CPCI Fifth Edition Design Manual Errata **5-02 – 11-27-17**

November 27, 2017

Addendum to Pages 7-35

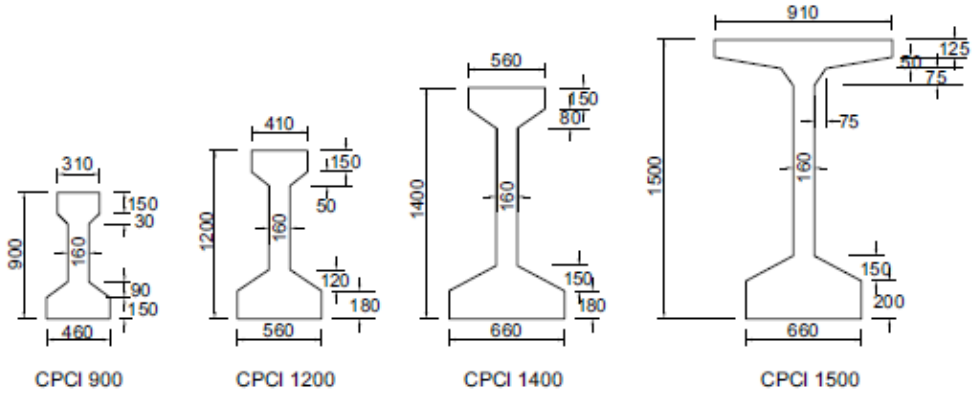
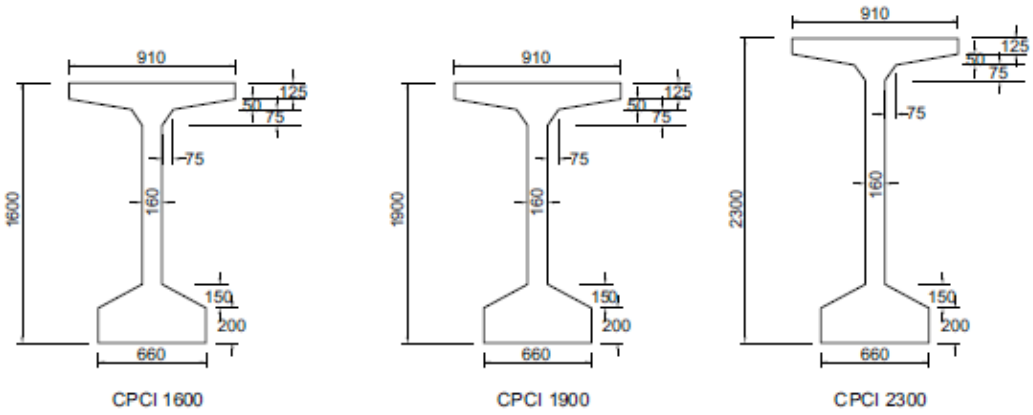
Figure 7.28. Page 7-35. This is a further addendum to Addendum # 5-01. The drawings have changed to include wider web, and flanges (top and bottom) increased by 10 mm. This is consistent with the section properties presented on the same page, which are unchanged. Revised drawings below, which have also been changed in the full PDF manual download.
